**Re: 316 Hudson Parade, Clareville – DA2020/1591  
Section 8.2 review of determination**

DA2020/1591 for alterations and additions to a dwelling house and garage at 316 Hudson Parade, Clareville was approved on 4 May 2021.

The applicant is now applying pursuant to Section 8.2 of the *Environmental Planning and Assessment Act 1979* ("the EPA Act") for a review of Council's determination.

**Photo 1:** Existing view from southern end of balcony

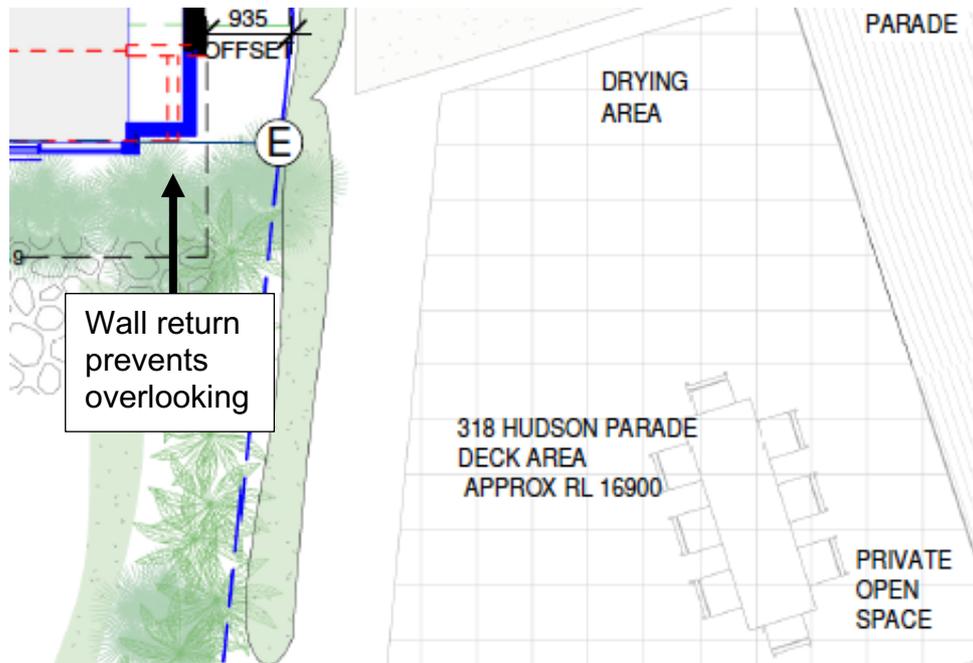
The proposal will result in an improvement to the neighbour's privacy. There exists a balcony on the western side of the existing habitable space over the garage that has direct sightlines to the neighbouring terrace at 318 Hudson Parade, as shown in the following photograph:

The proposal is to enclose the balcony from which this overlooking is available and to provide a return to the wall at the south-western corner of the flexible living space which will eliminate this view.

In this way the proposal results in an improvement to the privacy of 318 Hudson Parade whilst, at the same time, enhancing the amenity of 316 Hudson Parade.
